From: Samuel Miranda <sm0973@gmail.com>
Sent: Sunday, July 16, 2017 1:08 PM
To: Vietti-Cook, Annette; CMRSVINICKI Resource
Cc: McCree, Victor; Dean, Bill; Dave Lochbaum; Brett Chase; Banic, Merrilee; Beaton, Robert; Billerbeck, John; joshua.borromeo@nrc.gov; Drzewiecki, Timothy; gladys.figueroa-toledo@nrc.gov; Kirkwood, Sara; Wiebe, Joel; Broaddus, Doug; Bell, Hubert
Subject: [External_Sender] The NRC staff's review of Sam Miranda's 10 CFR §2.206 petition of November 15, 2016
Attachments: BB-Petition-Reply.docx

The NRC staff's review of Sam Miranda's 10 CFR §2.206 petition of November 15, 2016:

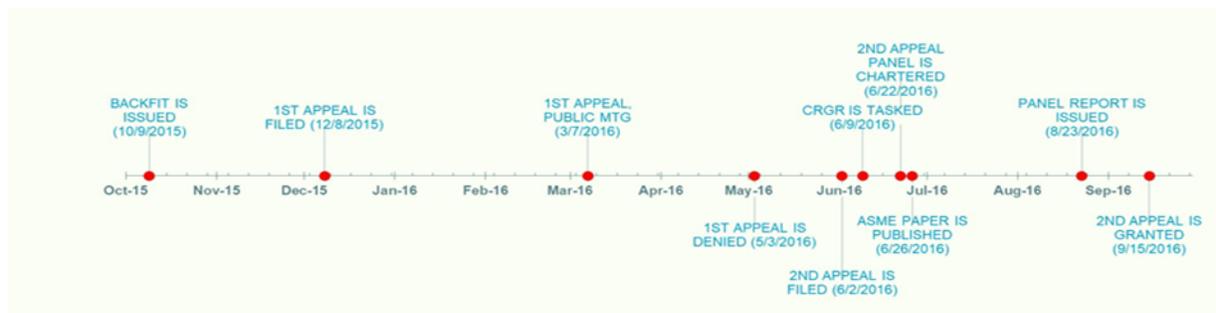
The BARP's purpose is stated on page 2 of its report [5]. It is to, *provide information and recommendations to support the EDO's decision on the appeal*. So, the BARP is not really a review panel. It's more of a Backfit Approval & Reversal Panel. This can be seen in the following timeline of events [17].

Note that it took the NRR appeal panel almost five months to consider, and ultimately deny Exelon's first appeal. It took the EDO only one week to issue a tasking memorandum, to the CRGR, to review the *lessons learned* from the backfit appeal, and develop a plan to apply them. Two weeks later, the EDO chartered an appeal panel of five (i.e., the BARP) to *provide information and recommendations* [5] to support his decision to grant Exelon's second appeal. One of the BARP's five panel members was also a member of the CRGR.

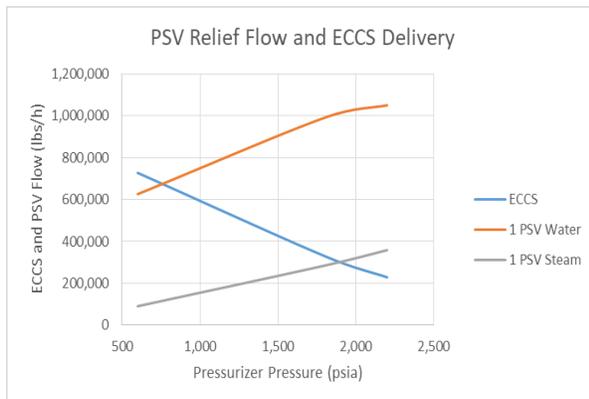
Again, the petition states, *The only necessary analysis (i.e., the non-escalation case) is not submitted*. This refers to the UFSAR, which still does not present the required analysis.

It is true that Exelon's July 5, 2000 letter mentions the criterion that prohibits Condition II events from generating more serious plant conditions. A mention does not constitute compliance.

The following figure, copied from [2], shows that the water relief rate through one open PSV will be greater than one million lbs/h. The same curve could also be interpreted as representing the water leak rate through the three seated PSVs. The curve is based upon the calculated relief rate for saturated water. The calculated relief rate for subcooled water would be much higher. If the minimum expected discharge water temperature is as low as 590 °F, as claimed by Exelon [7], then the calculated water relief, or leak rate would be greater than 1.7 million lbs/h.

A leak rate that exceeds the ability of the normal makeup systems to replace the lost water is defined as a LOCA. So, an IOECCS that occurs in the Byron and Braidwood plants will result in a LOCA, even if all the PSVs reseal, after having relieved water. Furthermore, Exelon does not explain how an unisolable leak rate that exceeds one million lbs/h could be deemed to be an acceptable outcome for an AOO, and the NRC staff doesn't ask.

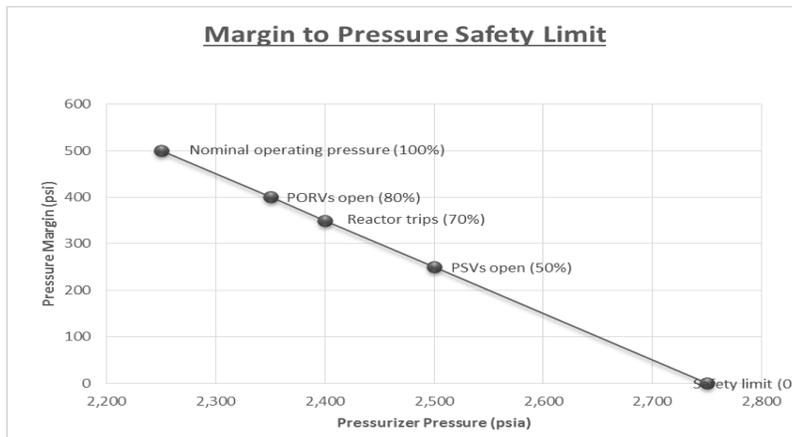
When the PORVs are applied, the margin of safety, to RCS overpressure is 400 psi (2750 psi minus 2350 psi). When the PSVs are applied, the margin of safety, to RCS overpressure is reduced to 250 psi (2750 psi minus 2500 psi). The margin of safety is thus reduced by 37.5%. For perspective, 150 psi is more than half the pressure that is developed inside the boiler of a steam locomotive. Note that the question has nothing to do with the valves' performance under steam or water relief conditions.

Exelon's plan to use PSVs, in lieu of PORVs, significantly reduces pressure safety margin, as depicted in the following figure.
